SETTING GOALS FOR SALMON SMOLT SURVIVAL IN THE DELTA

DISCUSSIONS ON THE PROPOSED EPA SALINITY STANDARD

Wim Kimmerer
BioSystems Analysis Inc.
3152 Paradise Drive
Tiburon CA 94920

August 10, 1994

Figure 1. Schematic of possible SSI goals. Top: Goal for Sacramento River is related to temperature, with a minimum SSI for all temperatures. Bottom: Goal for the San Joaquin River is related to the 60-20-20 index of unimpaired flow

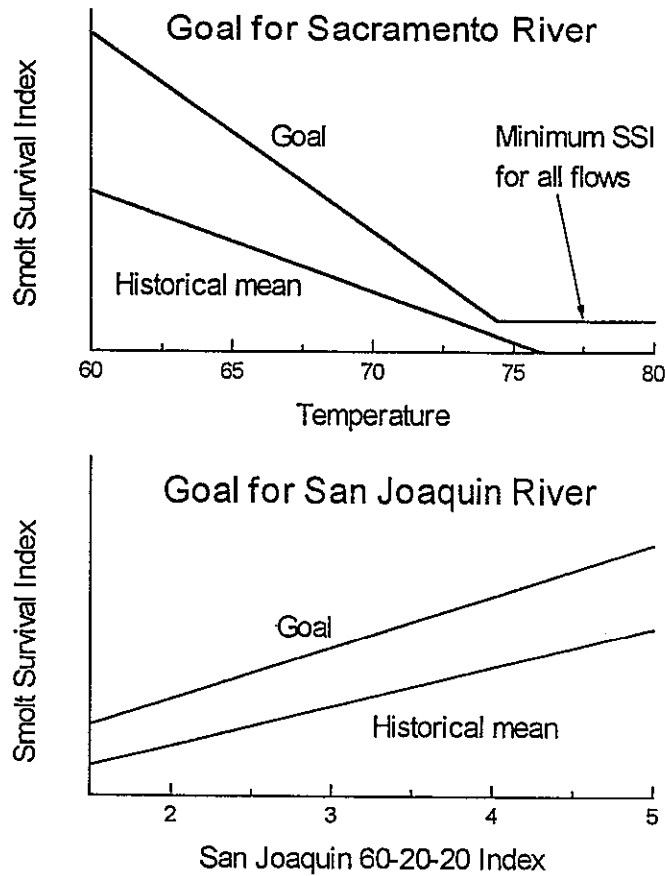
The goal should be a set increase over the existing relationship between survival index and temperature. The existing relationship for releases at Sacramento or Courtland with cross-channel gates open is (depicted in Figure 1, top, as historical mean):

Bruce Herbold suggested that the increase in the goal over the historical value could be either a doubling of survival for a given temperature, or alternatively, an increase in survival corresponding to closing the delta cross-channel gates. Coincidentally, the slopes corresponding to these alternatives come out about the same.

The group recognized that temperature in the delta is controllable to a limited extent, and the above standard could allow some activities that increase temperature, reducing the survival goal. Therefore the group suggested a minimum survival at all temperatures. In addition, EPA, the State Board, and other relevant agencies should re-examine the issue of temperature controllability in the delta, and revise this standard if temperature in the delta increases over the long term through local human actions (i.e. as opposed to global warming).

where a_1 is the new slope and S_{min} is the minimum survival (Figure 1 top, "goal"). This equation appeared to be the most acceptable of several alternative equations that were discussed.

T_x would be determined from the data, as would the baseline slope a in equation 1. Opinions varied about actual values of the remaining parameters. Bruce Herbold suggested a slope of 0.16, equivalent to a doubling of a, or an increase corresponding to shutting cross-channel gates. The value of S_{min} was somewhat arbitrarily set at 0.25, although opinions on an appropriate value ranged from 0.1 to 0.5.

Participants preferred a goal that would improve survival in critical years more than in wet years. The historical mean value of SSI is about 0.09 in a limited number of critical years, (≤ 1.5 MAF) and 0.5 in wet years (≥ 5 MAF). There was general consensus that the goal for critical years should be a 2- to 3-fold increase over historical values, since populations are more vulnerable during low-flow conditions. The goal in wet years could be set at a value higher than the historical mean, say 0.75. If the goal for the survival index were scaled linearly to unimpaired flow, it would have the following form (Figure 1 bottom):
